Date: September 24, 2026

From: Sean Conrad, Planning Manager

Re: Response to open record letters - Meadowlark Energy Storage LLC, Conditional Use Permit/Site Plan Review, File 785-26-000057-PLNG

Attachment A

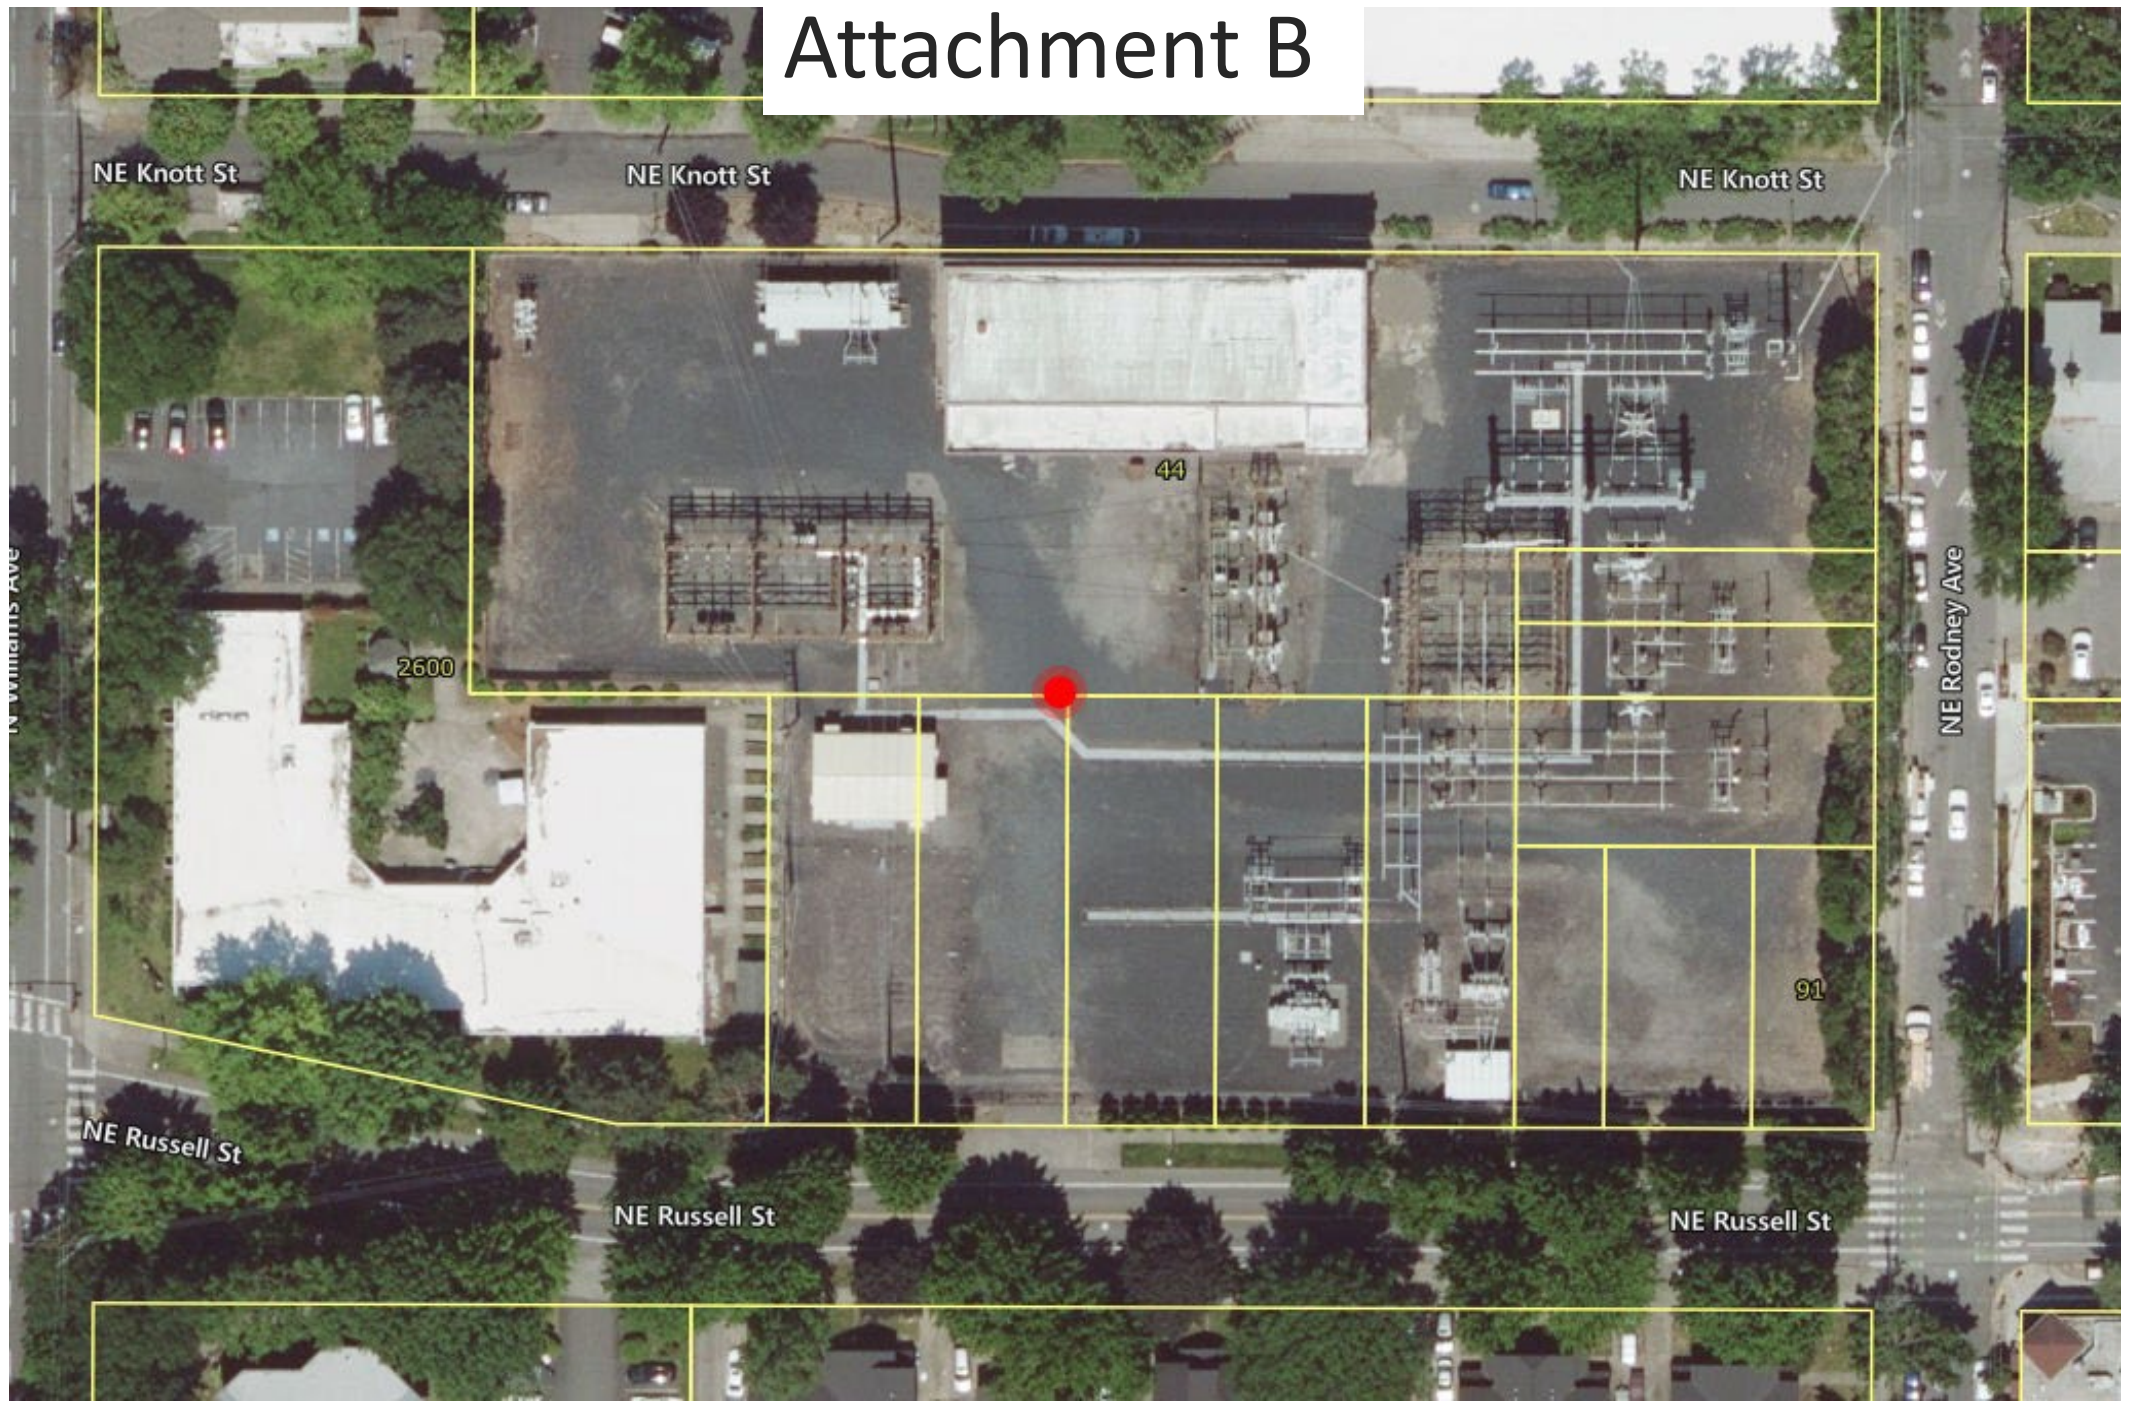
The area on the substation site recommended for landscaping under condition B.2 is located along the substation's east side. Here, the distance between the substation perimeter fence and the sidewalk is approximately 45 feet. This distance is fairly consistent until the northeast corner of the substation's security fencing. At this point the distance between the fencing and sidewalk widens to sections exceeding 200 feet. The northwest corner of the substation's fencing is within 20 feet of the sidewalk, however, this area is outside the scope of review for this permit application. Staff presented a graphic

during staff's presentation at the public hearing that clarified the extent of landscaping required under condition B.2. (See Attachment A).

Submit a landscape and irrigation plan to city staff for review and approval. The landscape plan shall include a minimum ~~20~~ 10 foot wide landscape area between the sidewalk along SW Langer Farms Parkway and the access driveway/riser pole location for a total landscape area of 15,000 square feet. The width of the landscaping and types of planting may be modified if aerial and/or underground utilities limit or prohibit landscaping. The landscape plan shall provide for a combination of ground cover, bushes and trees to create a continuous visual landscape corridor.

(Note: The driveway along SW Langer Farms Parkway will need to be relocated to accommodate the minimum amount of required landscaping. In some locations, the width of the landscape strip will need to exceed 10 ft. to reach the required 15,000 square feet)

Attachment D

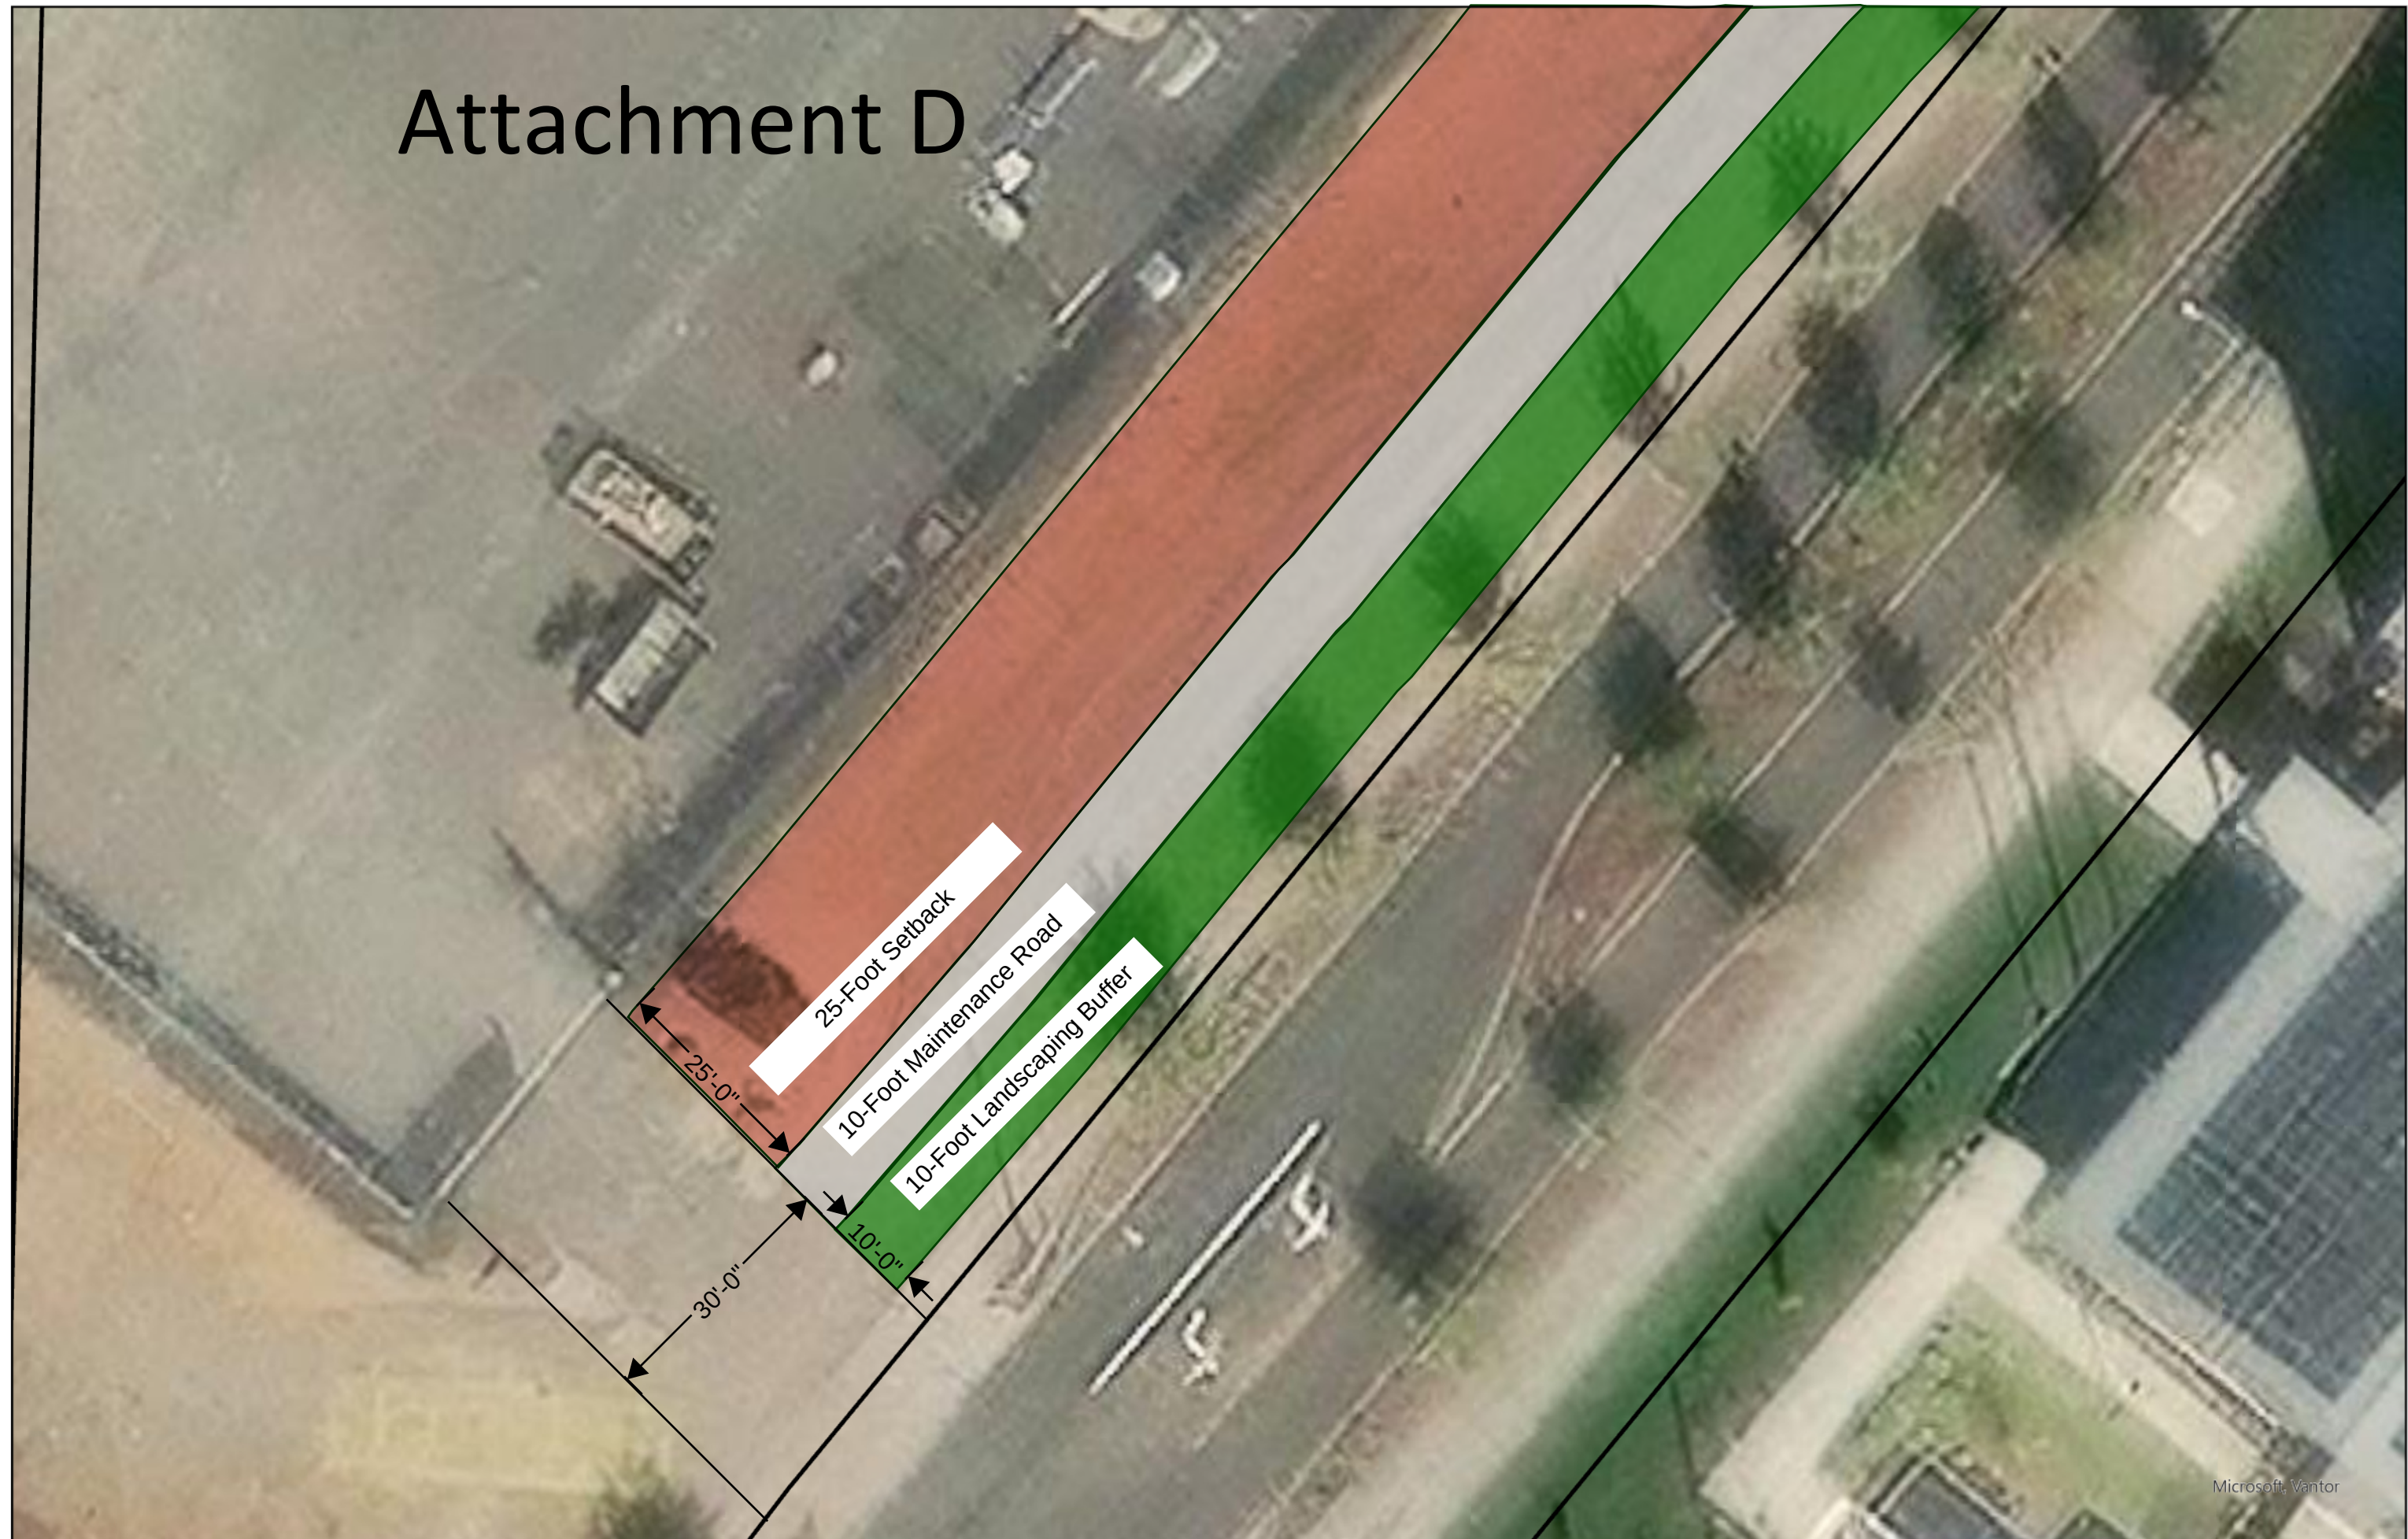
The recommended updates to condition B.2 will require an approximate 300 foot portion of the driveway to be relocated between 1 and 6 feet further from the sidewalk. As mentioned in staff's response to PGE's letter, it is unclear why moving the existing driveway on the substation site will create a security and/or safety issue based on the information contained in the letter. However, the updates to condition B.2 will permit the majority of the driveway to remain in place with the landscaping between the driveway and sidewalk counting towards the required total amount of 15,000 square feet (see Attachment D). The intent of the condition would be to place a wider landscape area between the sidewalk and riser pole/security fence location in an area of the substation site that can accommodate the wider landscape area instead of a uniform 10 foot wide landscape strip.
